PRELIMINARY OVERALL AREA DEVELOPMENT PLAN (POADP)
THE HEIGHTS AT STONE OAK II #358 – C

PRELIMINARY OVERALL AREA DEVELOPMENT PLAN (POADP)
THE HEIGHTS AT STONE OAK II #

Re: The Heights at Stone Oak II POADP # 358 - B

TO: Burt Rubio **Date** May 20
FROM: Elizabeth
ITEM NAME: The Height @ Stone Oak **FILE #**
RE: POADP

THE HEIGHTS AT STONE OAK II
POADP

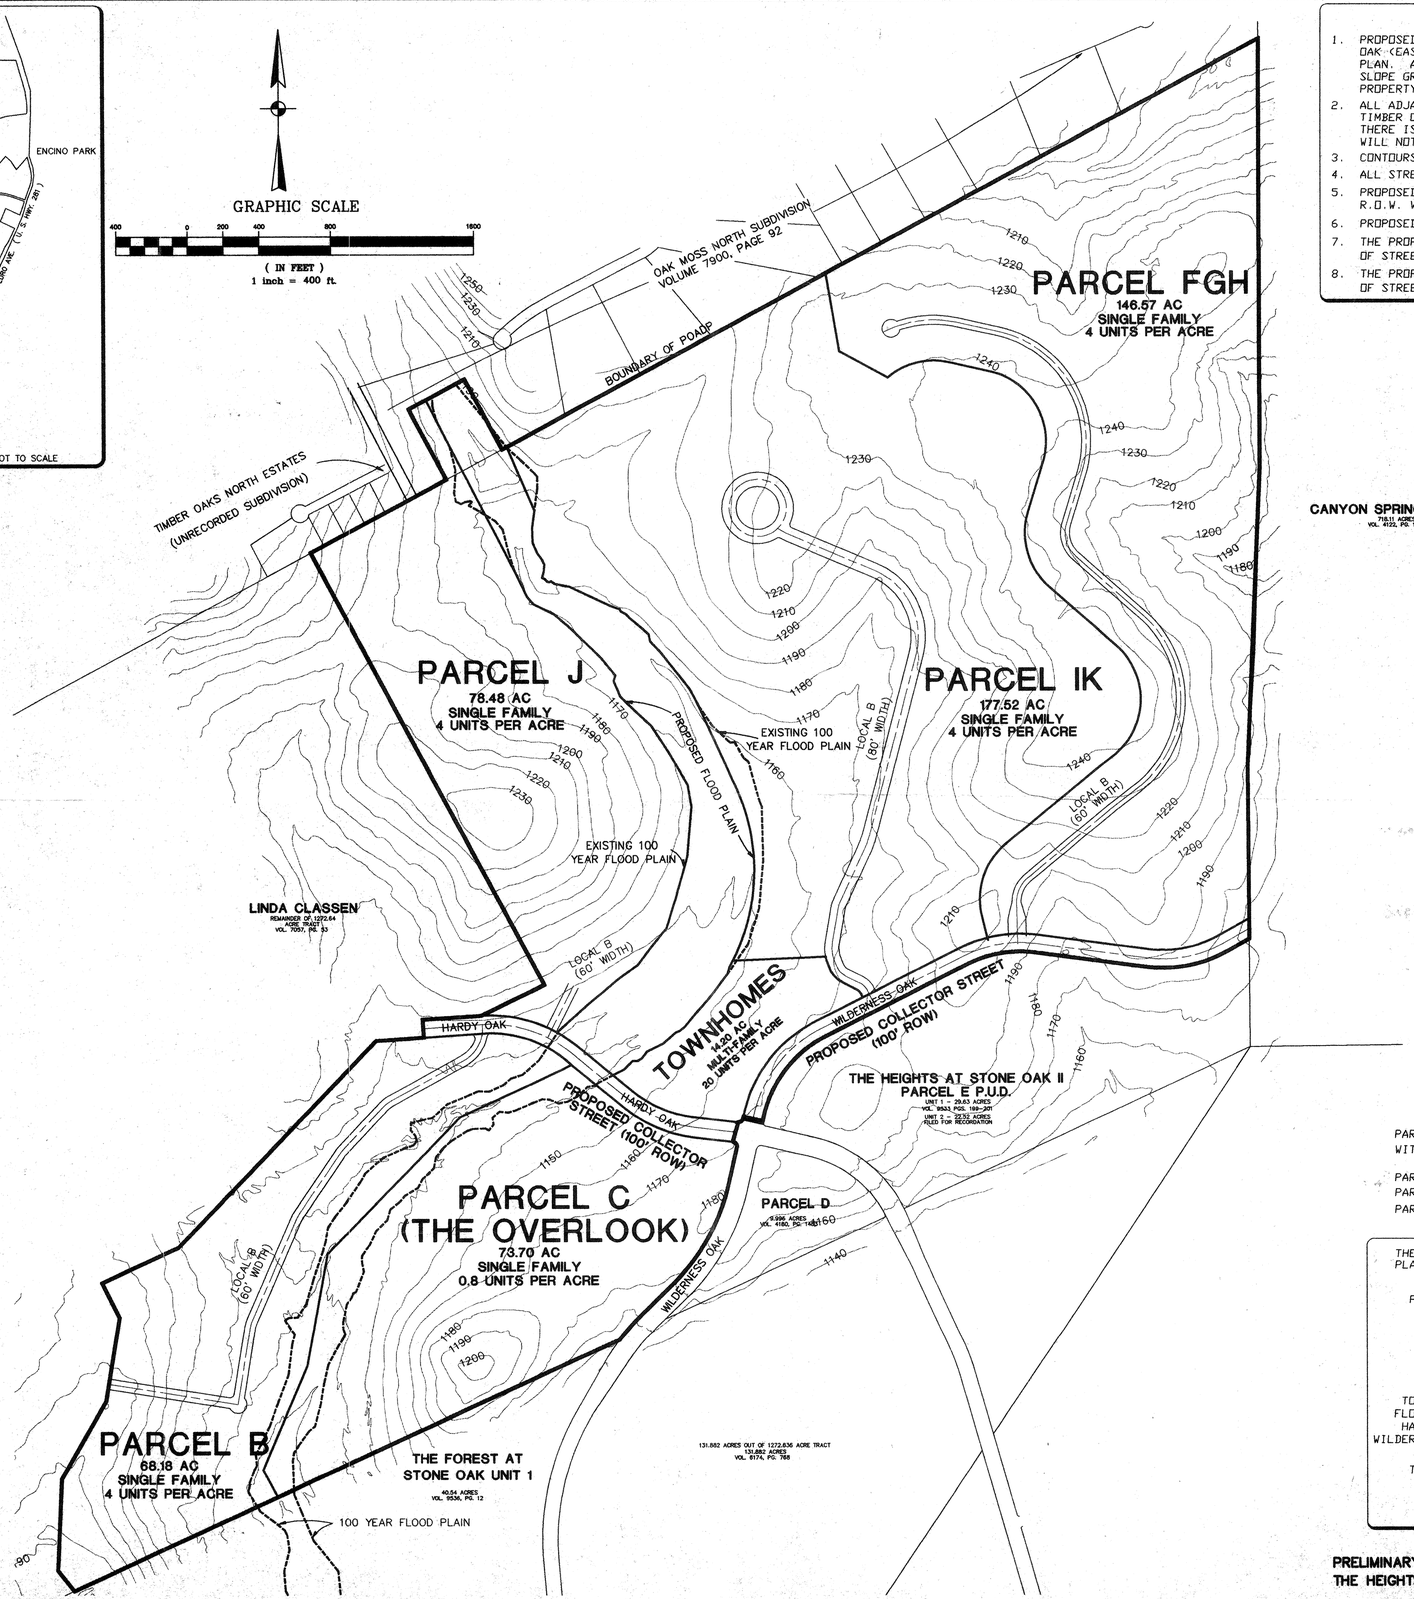
- Based on the topography, a Flood Plain Study and drainage review will probably be required during the platting process.

- This development will probably need to conform to requirements associated with development over the Edwards Aquifer. For additional information about these requirements you can contact SAWS at 704-7305.

- A variance will be required for Hardy Oaks and Wilderness Oaks. Staff will support the variance request, subject to Planning Commission approval.

Comments: FLOOD PLAIN REQUIREMENTS AND DRAINAGE EASEMENTS WILL BE REQUIRED AND ADDRESS DURING THE PLATTING PROCESS.

β. Submit TIA
